COMMENTS ON THE TMC REPORT

“RENA – FULL WRECK REMOVAL FEASIBILITY APPRAISAL”

Date: 18 August 2014

Our Ref: 5750/LOCS/NEH/R008

Figure 1. ADUS April 2014 Screenshot of Bow Area.

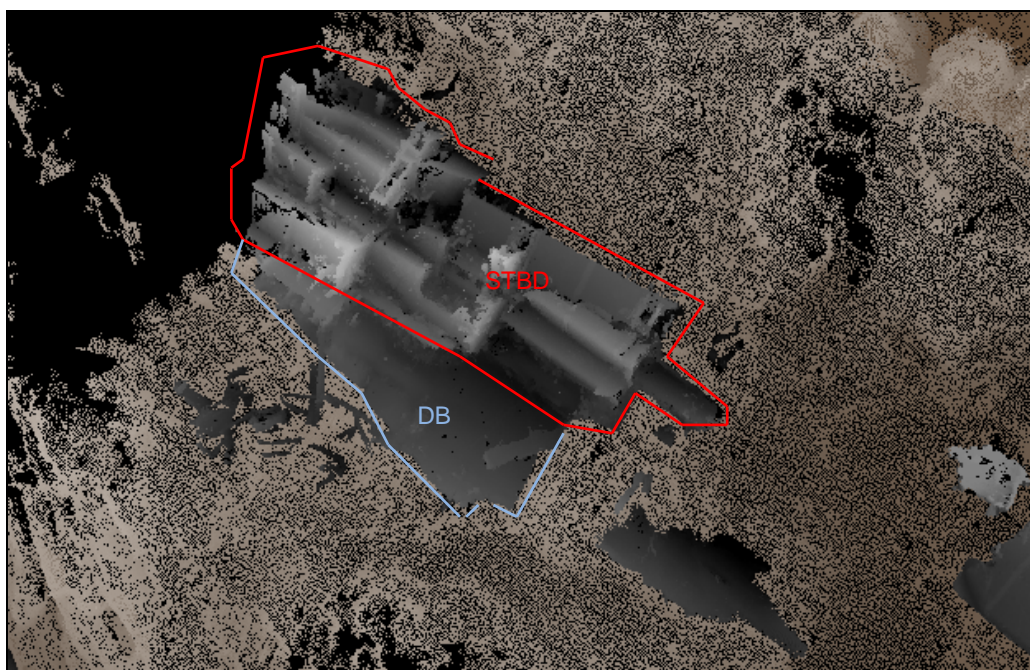
- 3.5.23 A snap shot of an extract taken from the ADUS survey is provided in the TMC report at page 19 of 107 (Figure 4 – ADUS Screenshot (Bow Section Double Bottom and Starboard Side)).

The extract shown below at **Figure 1** shows the starboard side of the bow section (coloured **RED**) and double bottom of the bow section (coloured **BLUE**). The black area in the top left hand corner of the ADUS screenshot shows an area not surveyed due to shallow water, it can be seen from the screenshot that the upper edge of the starboard side is within the black area (not surveyed), this is the area referenced in the Gorman & Mitchell report and discussed at paragraph 3.5.4 above.

We know from other figures provided in the TMC report⁸ that the forward end of the bow section is contained within a 2 metre contour. From the evidence provided, scanty though it is, I am of the opinion that at least part of the starboard side of the bow section is shallower than the claimed -1 metre LAT.

I will reiterate what is stated in paragraph 3.5.1 of this report, there is no evidence provided that shows that the -1 metre LAT was ever achieved and furthermore there is no evidence provided that shows that this level has been maintained. In fact the evidence provided in the Beca provided Gorman & Mitchell report and the two MNZ weekly SITREPs would appear to show the opposite and that movement has caused the bow section move into shallower water. Owner and TSC must provide documented evidence that the -1 m LAT was achieved and is being maintained.

Figure 2: Debris Field, May 2014

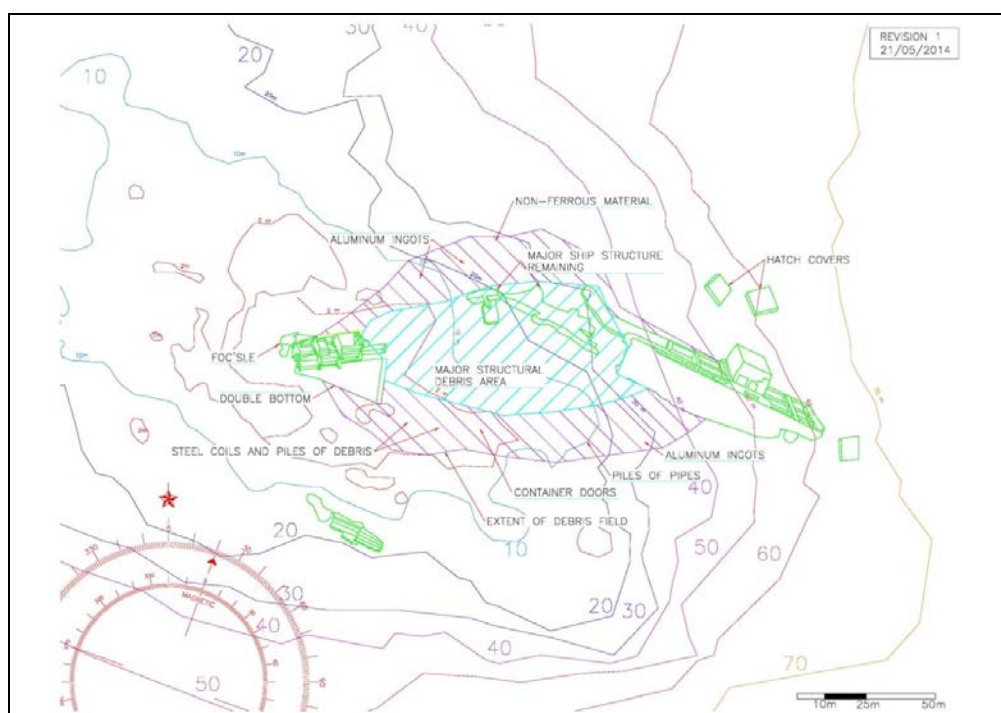
The extent of the principal debris field is shown in the figure below at **Figure 2** which is extracted from the TMC report¹⁰

The TMC report advises that following the latest underwater surveys, clean-up operations to remove the debris field have commenced. Resources include divers, an electromagnet and an orange peel grab. At the time the TMC report was produced (end of April 2014), 467 tonnes of metallic cargo, 298 tonnes of ship debris and 119 tonnes of non-metallic debris had been recovered. This totals 884 tonnes of mixed debris. TMC estimate there is approximately 4125 tonnes of debris remaining within the debris field. The report advises that in general the debris is considered relatively benign,

Figure 3: ADUS Side-Scan Sonar Targets (suspected debris field).

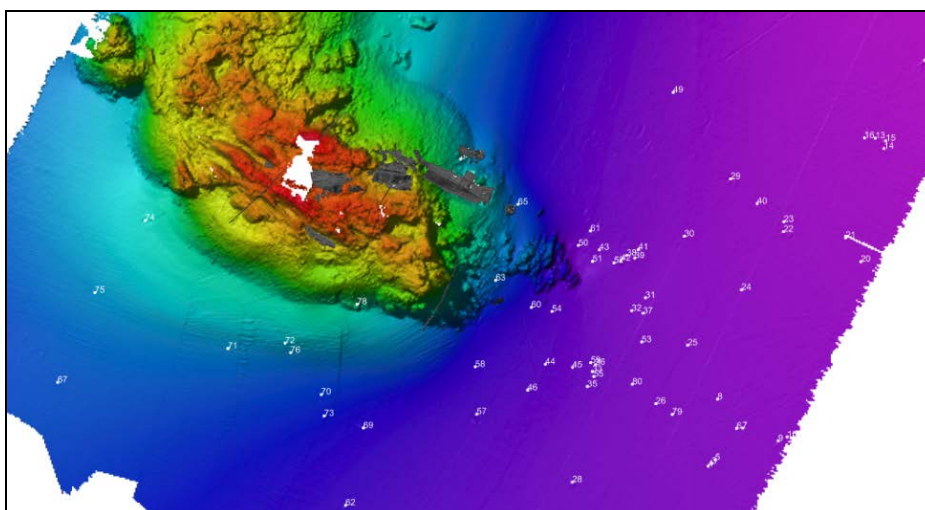
3.5.12 The TMC report also advises that the side-scan survey undertaken in April 2014 of the level seabed surrounding the Astrolabe Reef revealed a number of possible debris targets. Whilst the various locations have been documented, at the time the TMC report was written no targets have been positively identified as debris. The extract below¹¹ shows the various targets identified within the ADUs survey as "suspected" debris targets:

Whilst it may be the case that none of the targets shown above have been "confirmed" as debris targets, it can similarly be stated that none have discounted, as such it is highly likely that at least a percentage of these targets do consist of debris. It is well known that items of debris continue to

Figure 3: ADUS Survey in 2012 (Red) and April 2014 (Grey).

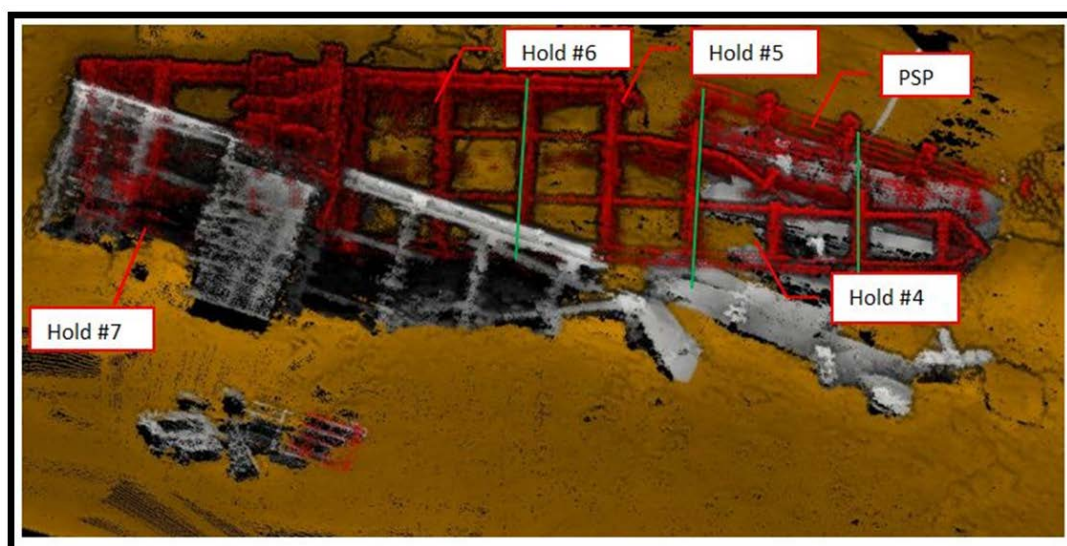
- 3.5.13 Chapter 4.4 of the TMC report deals with the Aft Section of the wreck. The aft section is fully submerged and laying on its starboard side at 63° with an aft trim of 4°, at its deepest the aft end is at 56 metres water depth. The total estimated weight of the aft section is approximately 10,353 tonnes (prior to any removal), however reference should be made to the table extracted from the TMC report and provided as **Figure 4** of this report which shows that the estimated weight remaining of the aft section is 7727 tonnes.
- 3.5.14 The April 2014 survey shows that Holds number 4 and 5 have collapsed completely. The significant changes to the section are clearly illustrated in the illustration below which shows the position of the section in 2012 (shown in Red) and 2014 (shown in Grey).

The survey would appear to show that all longitudinals forward of the accommodation have been compromised and that Hold 7 appears to also be crushing.

Figure 6: Debris Removal Barge Mooring Arrangement.

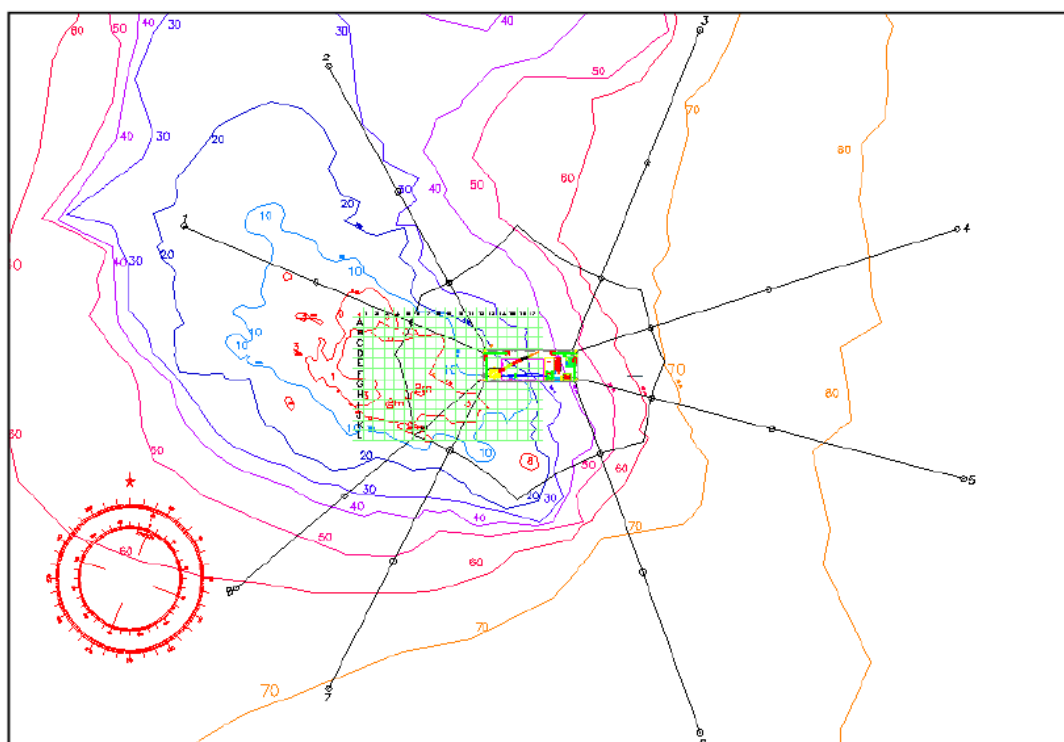
The drawing at **Figure 6** below shows the planned mooring spread. The barge will use soft lines which will be connected to the anchor/chains. This will allow the spread to be moved around the debris field using the mooring winches fitted to the barge. Despite TMC's concerns at damaging the reef using anchors, this is the method being utilised.

The removal operation will be undertaken systematically. The debris field has been sub-divided into a datum grid. The grid system is used in conjunction with a Hypack (navigation) software package already installed on the barge. Each of the grids forms a 10m x 10m box. The navigation software will be used to position the LARS (Diver launch and recovery system) exactly within the grid reference.
